ADDENDUM No. 7

Date January 5, 2016

Project Name Southeast Allandale Neighborhood Water and Wastewater Improvements Rebid (IFB 6100 CLMC 538B)

C.I.P. No. 2231.192

**WASTEWATER PLAN AND PROFILE
45TH STREET (WWM-H) STA. 0+00 TO END**

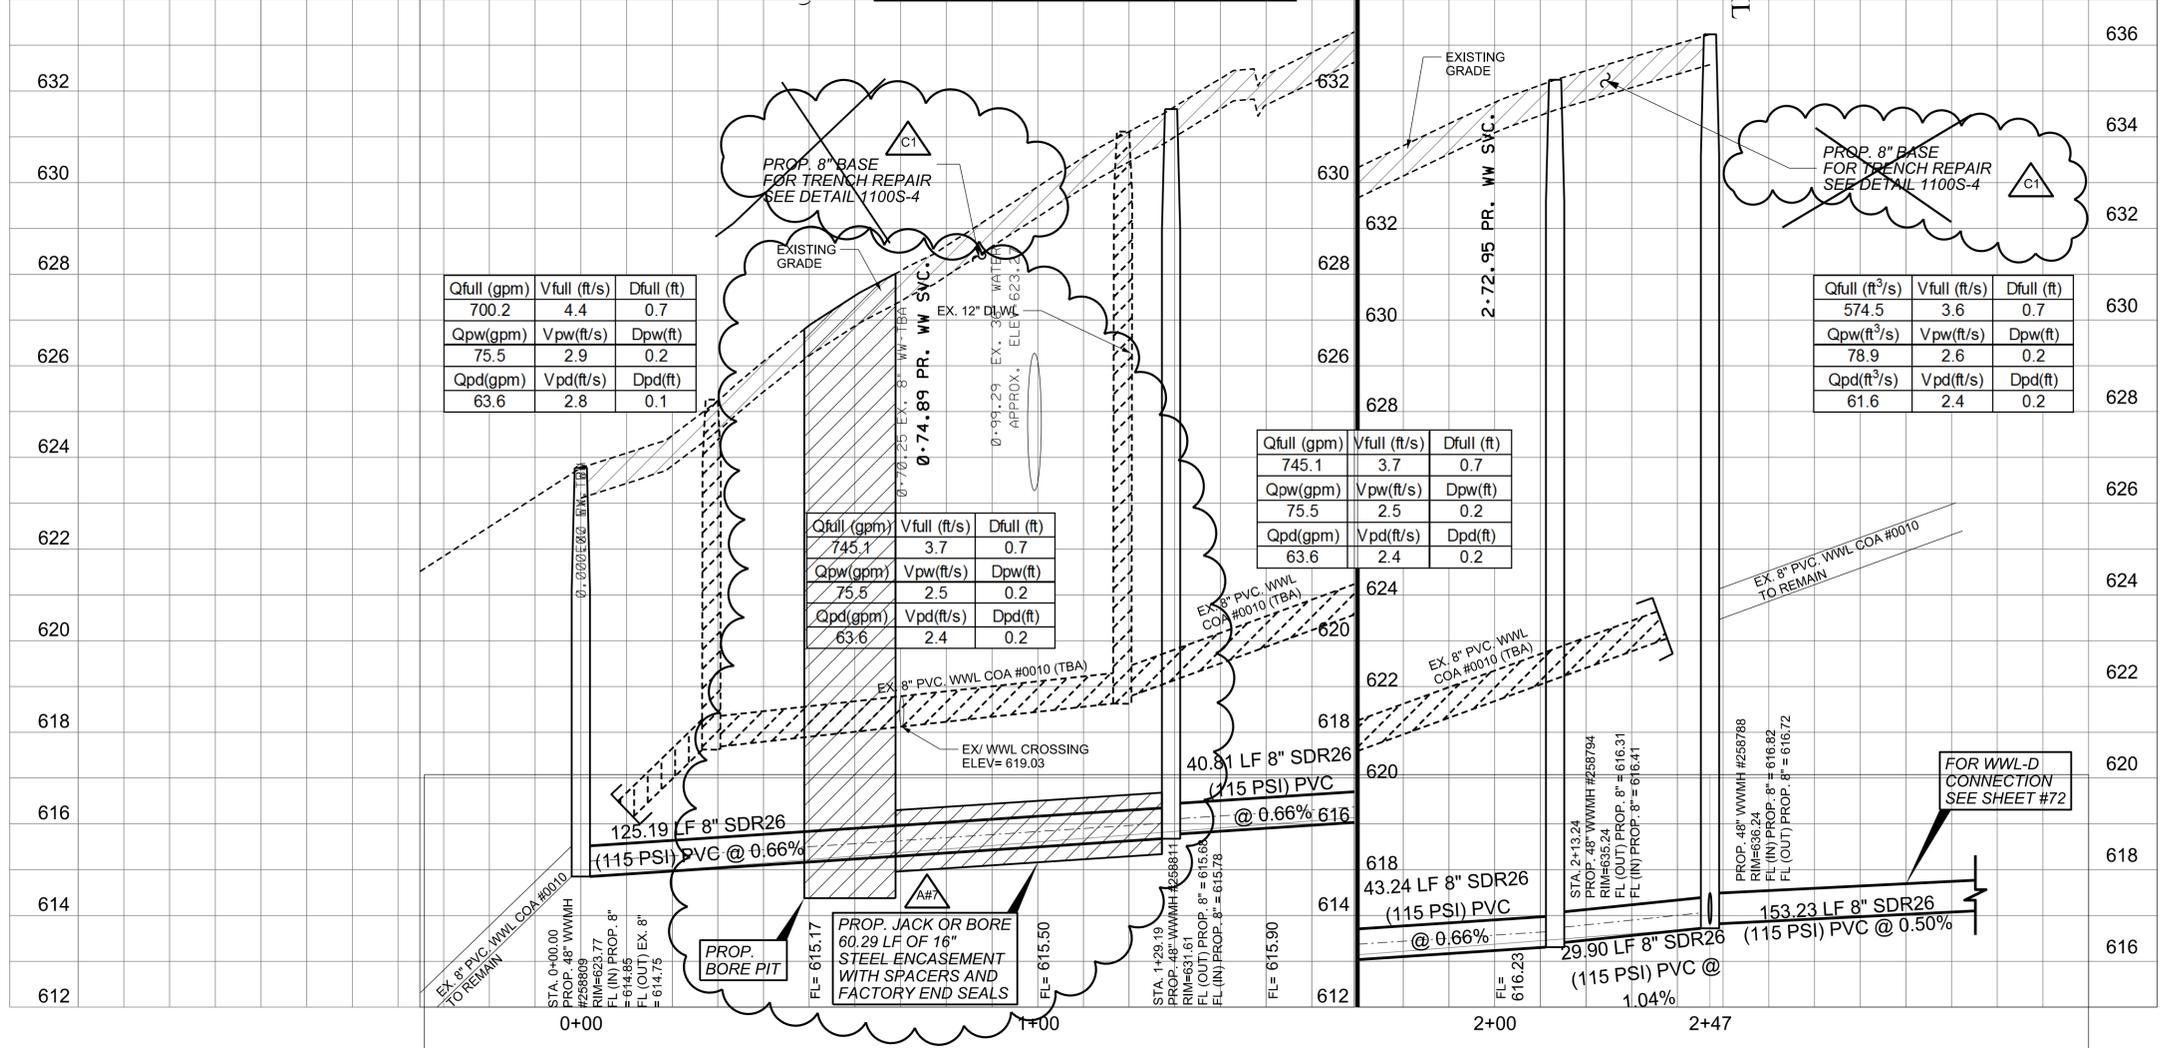
REPLACE: SHEET 79 IN ITS ENTIRETY WITH ATTACHED SHEET 79.

CT 1	EZ	07/21/15	REVISED TRENCH DETAIL
A#5	JP	11/24/15	REVISED WWM-H P&P
A#5	JP	11/24/15	ADDED NOTE #3 FOR TRENCH DETAIL
A#7	JP	01/04/16	ADDED JACK OR BORE IN PROFILE
